Stage 1 Road Safety Audit

**Proposed Social Housing Development at
St Joseph's Rd, Portumna**

On behalf of **Galway County Council**

May 2025

3.2.3 Refuse Bins

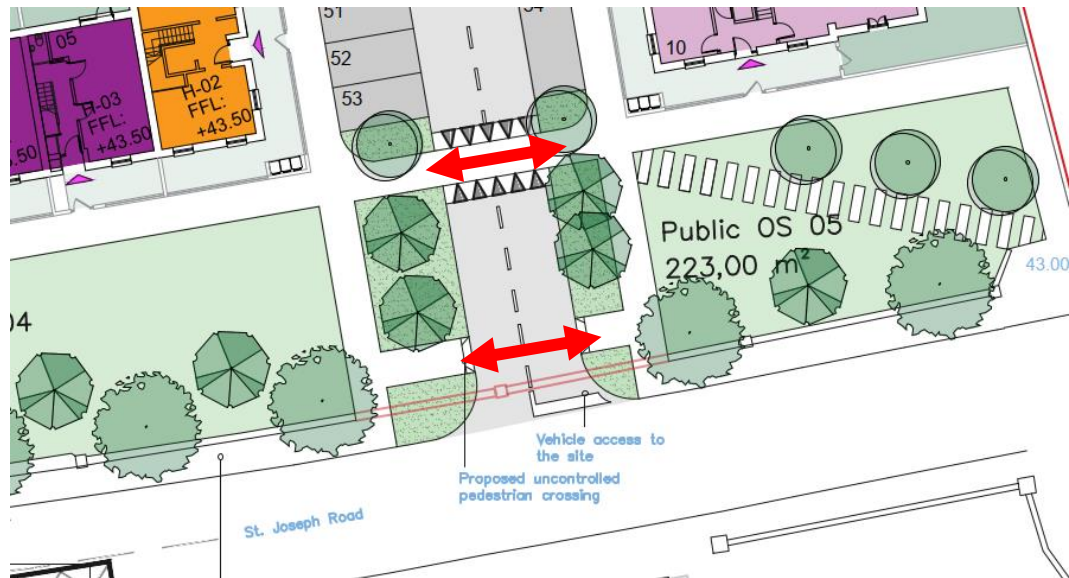
Problem: There are a number of units that do not have direct carriageway frontage, including but not limited to units 1-9. There is concern that on bin collection days the residents will leave multiple rubbish bins together on an area of the footpath with easy access to the carriageway / refuse vehicle. Multiple bins at the same location may block the footpath for impaired pedestrians. The pedestrian may attempt to pass the bins by either walking on the grass or possibly entering the carriageway.

Hazard: Slip / falls or impact from passing vehicle injuries may result.

Recommendation: The Design Team should provide a paved area off the footpath for refuse bins to be placed on the day of collection.

3.3.2 R354 Signal Controlled Crossing (1)

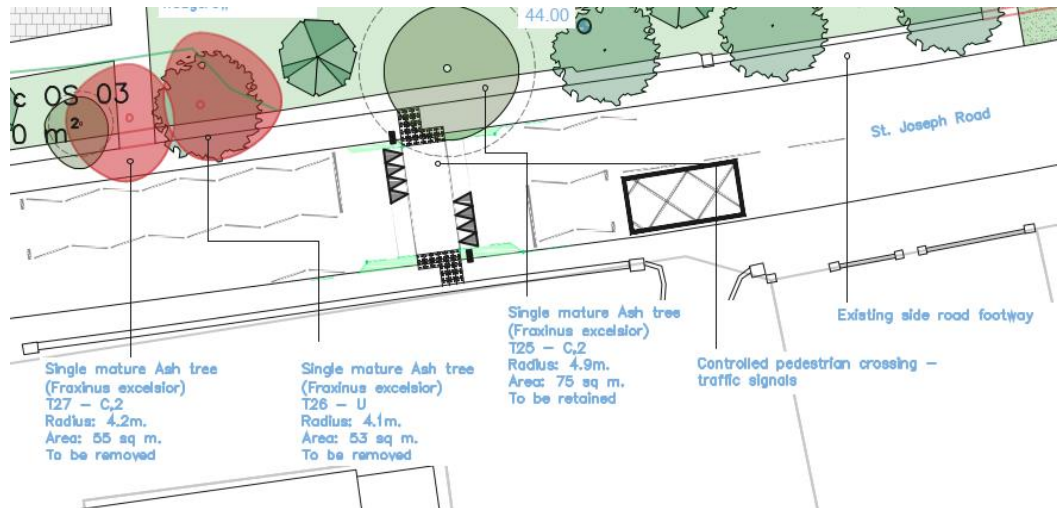
Problem: There is a proposed signal-controlled pedestrian crossing located on the R352. The width of the crossing appears to be narrow, maybe 2-3m. The R352 is likely to be used by buses and coaches. There is a historic problem with confined flat top tables where bus passengers sustain injury from the “up and down” ramps being close together, known as “the double bump”

Hazard: Bus passengers may sustain personal injury due to the double bump.

Recommendation: The Design Team should widen the flat top element of the crossing to 6m.
